## Response to the Reviewers' Comments

The authors would like to thank the reviewers for the precious comments and suggestions on the technical contents and presentation of our manuscript “Runtime Power Management of Battery Electric Vehicles for Extended Range with Consideration of Driving Time,” submitted to IEEE Transactions on Very Large Scale Integration (TVLSI.) This revised manuscript has been greatly improved thanks to the reviewers’ invaluable advices. We have revised the manuscript faithfully following the reviewers’s comments. We include the newly added or significantly modified parts in the revised version of the paper also in Response to Reviewers. We highlight the important technical content changes and set those parts in a red color in the revised paper.

Fig. 2: (a) Range-speed experimental data for Chevrolet Bolt [36] and (b) comparison with simulation results of the proposed EV power model.

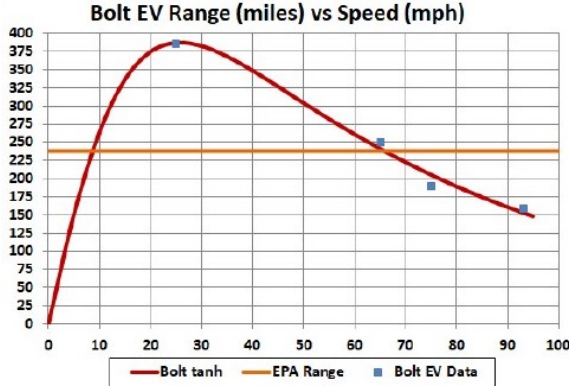
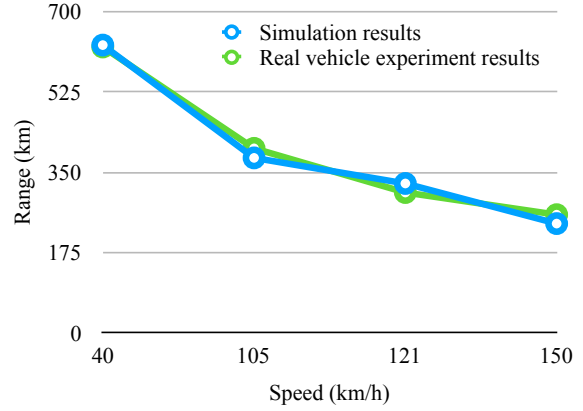
**R1-C2** It is not clear how to validate the power model of EV. As the author mentions that accuracy of power model is quite important, it is good to see the power model in this paper can be validated by some real measurement results.

We further evaluate the model accuracy with the range-speed real vehicle experiments as shown in Fig. 2(a) to confirm the derived power models are close enough to the real vehicle measurement data [32], [33], [34], [35], [36]. We refine the coefficients until all the available data values match well.

As a result, the derived EV power model well matches with the range-speed experimental data as shown in Fig. 2(b) as well as the top speed and maximum acceleration setting the aerodynamic resistance, rolling resistance, curb weight, etc. with the known values. The errors in the range-speed simulation is merely 1.4%, the time for 0-to-100 km/h error is 7.8%, and the top speed error is 3.0%, respectively.

Fig. 12: Velocity profile comparison with  $EDP$ ,  $E^2DP$  and  $E^3DP$  on Serrano Avenue in Anaheim Hills.

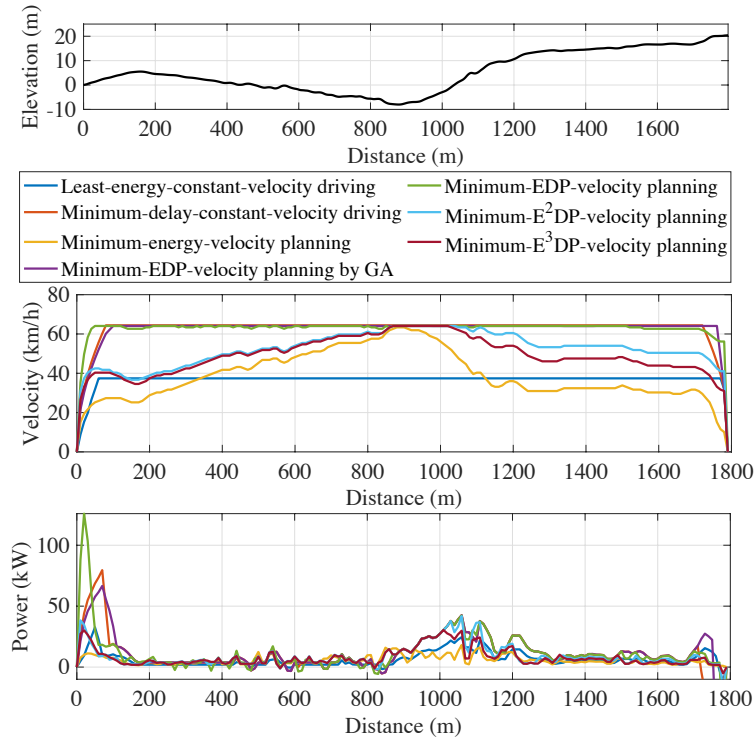
**R1-C3** The optimality of the proposed scheduling algorithm is unclear. The author should add several paragraphs to discuss this topic. It is also to see the comparison baseline is well accepted to show the advantage of the proposed algorithm.

We also updated Fig. 12 and Fig. 13:

Fig. 11: Histograms of velocity and acceleration for the proposed energy-aware-velocity planning methods without an acceleration constraint (a) and (b) and with an acceleration constraint (c) and (d), respectively.

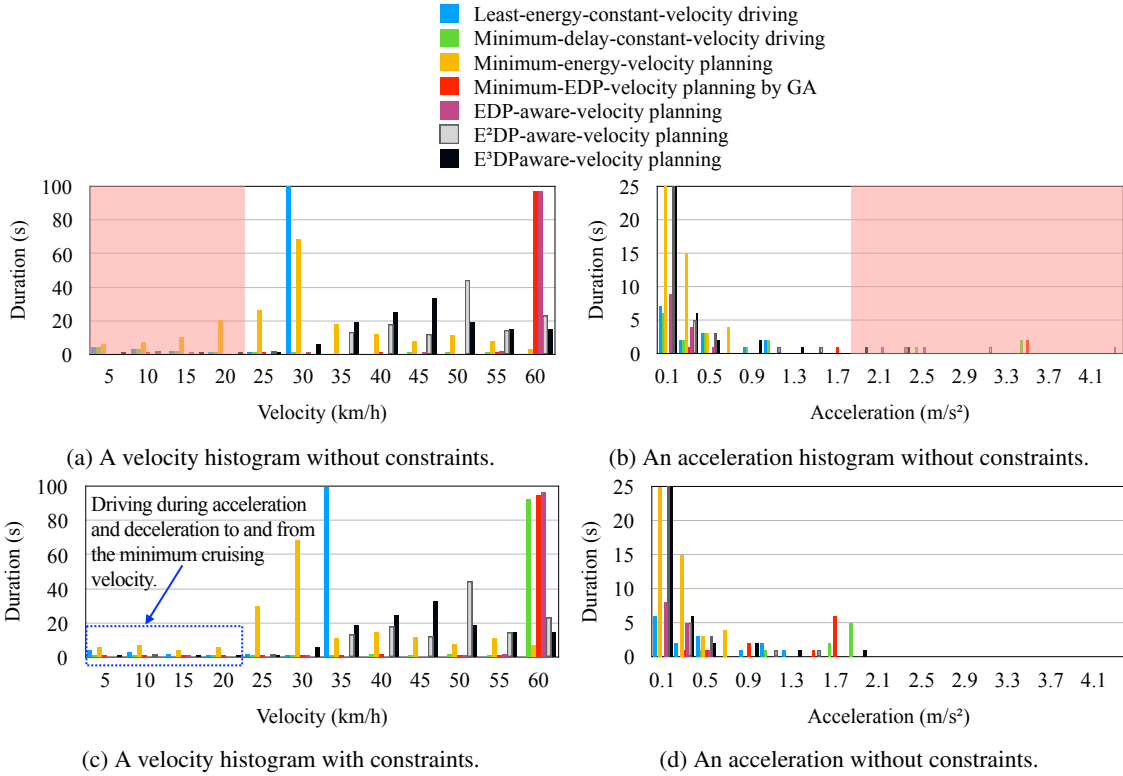
**R2-C2** It would be good to have more discussion on the assumptions of the approach and the experiments, e.g., how much can the velocity be changed in practical scenarios without impeding traffic and causing unsafe situations (also depending on the road conditions and whether it is urban or rural environment I suppose). Currently, there only seems to be one constraint on not slower than 10 km/h.

We quantize the velocity and acceleration values and make a histogram to analyze population of velocity and acceleration for the proposed energy-aware-velocity planning methods. Fig. 11(a) and (b) show two histograms of the driving schemes in Fig. 12, which do not have velocity and acceleration constraints. We avoid a cruising velocity lower than 25 km/h and an acceleration higher than  $2.0 \text{ m/s}^2$  in this paper without loss of generality. The acceleration of  $2.0 \text{ m/s}^2$  is the same as the maximum acceleration of compact cars designed to be used primarily used in urban areas (13 seconds of 0-to-100 km/h time).

Fig. 11(c) and (d) shows the velocity and acceleration histograms with the constraints. Once we run the DP for the first time without constraints, we analyze the histogram, adaptively determine the minimum cruising velocity and maximum acceleration constraints, and run DP again. We keep the same constraints for online recomputation whenever unexpected interrupts occurs.

Fig. 8: Altitude changes in the real road benchmarks.

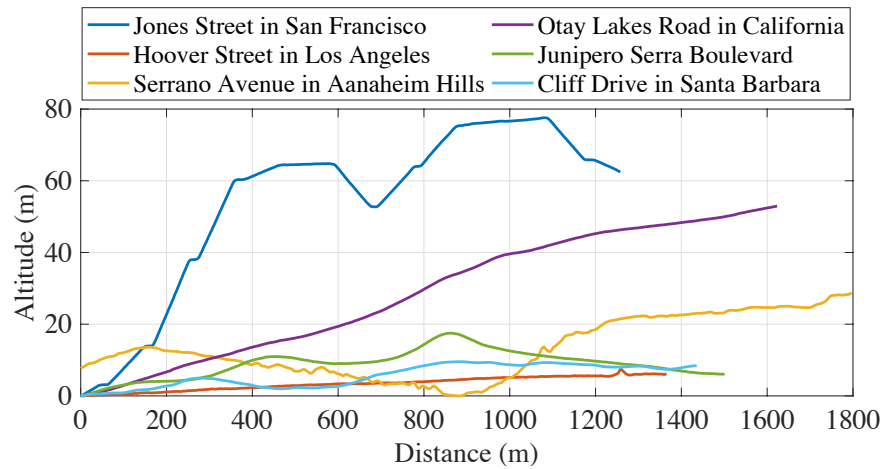
**R2-C3** Related to the last point, it would be good to have more discussion on the road benchmarks, e.g., how they are generated and how representative they are. The optimization results significantly depend on road slope. It would be good to use a variety of real road segments for testing.

**R2-A3** We appreciate the reviewer's comment. We replaced the previous synthetic road benchmarks with the real road benchmarks. We made six new real road benchmarks from various locations in California. The first three roads are in cities. Jones Street in San Francisco and Hoover Street in Los Angeles are two representative city landscapes such as hills and flat roads, respectively, and Cliff Drive in Santa Barbara is a mixture of those. The second two roads are in mountain areas: Serrano Avenue in Anaheim Hills and Otay Lakes Road in San Ysidro

Mountain in California. The last road is Junipero Serra Boulevard connecting San Francisco and San Jose. The details of road data is summarized in Table II, and Fig. 8, which visualize the altitudes of the road benchmarks. We also revised all the associated contents with the new real road benchmarks.
